# Staff Report

TO: Advisory Design Panel

FILE NO: 3220-GibsonsWay-LotA&C

SUBJECT: OCP and Zoning Amendment for Lot A and C Gibsons Way – commercial and high density residential uses

Figure 9: Landscape Plan showing Building A and Building B

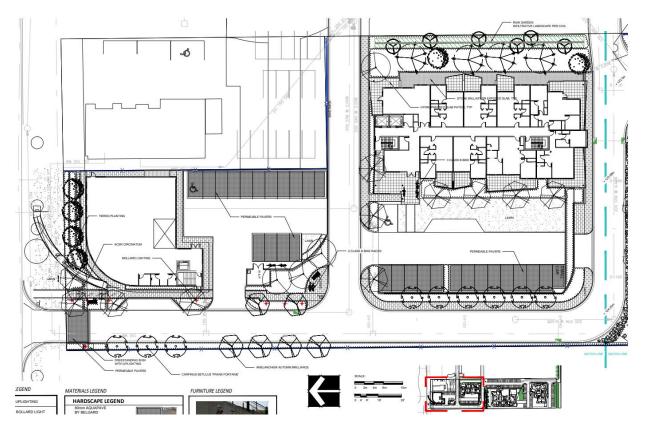
When looking at the Landscape Plan, as shown in Figure 9, Building B (residential) is off set to the east from Building A (commercial), but is adjacent to the 101 Brewhouse and Distillery parking lot and separated with 22 ft (6.7 m wide circulation road).

Along the north side of the building, a permeable paved pathway and 4 mature trees with shrubs beneath are proposed. Currently there is no landscape buffer along the south side of the parking lots for the proposed new building and the 101.Staff suggest that additional landscaping may be needed to provide some screening of the parking from the residential areas.
